State of Utah
DEPARTMENT OF ENVIRONMENTAL QUALITY
DIVISION OF WATER QUALITY

September 28, 1992

RE: Revised Ground Water Discharge Permit
Application

Enclosure #2 Sheet 1/1

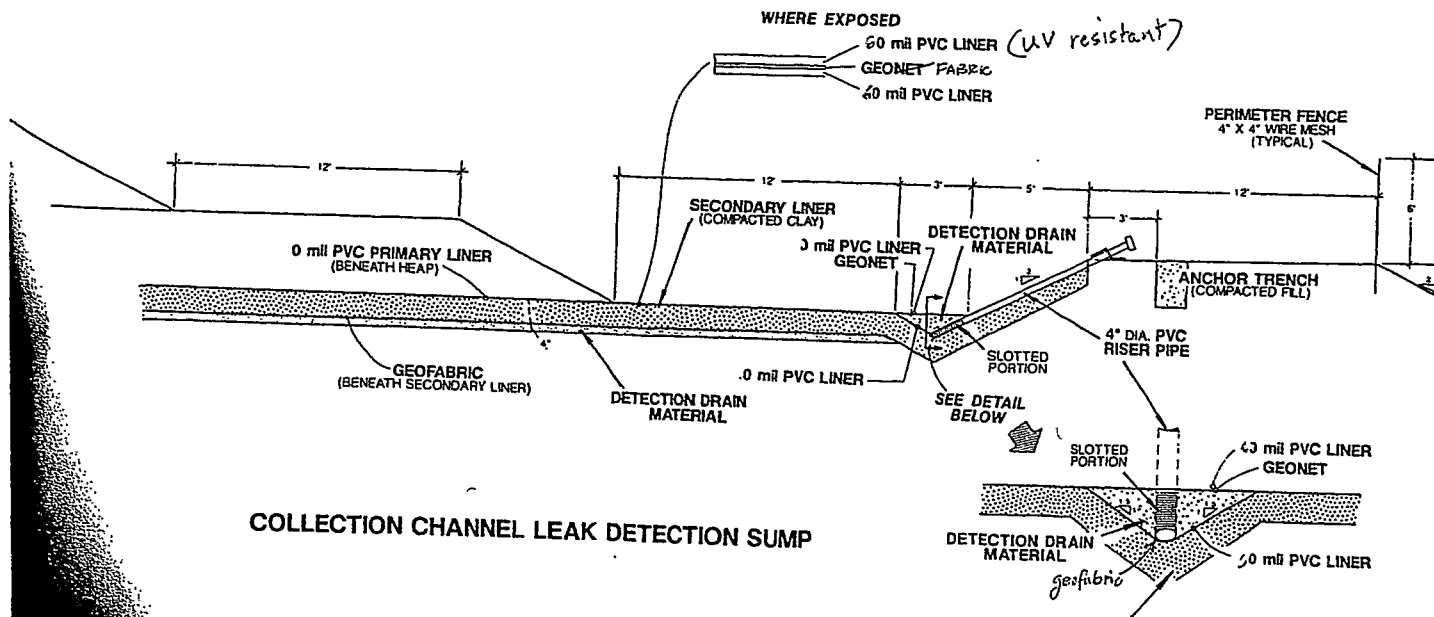
1. An analysis of the heap structural stability should be submitted with the preliminary design.
2. The asphalt cover and the synthetic flexible membrane liners should be analyzed for compatibility and corrosion resistance with the leachates. The manufacturer's design literature on this should be submitted with the preliminary plans and specifications.
3. Heaps will need to have a dual perimeter liner installed. An example drawing of this is included.
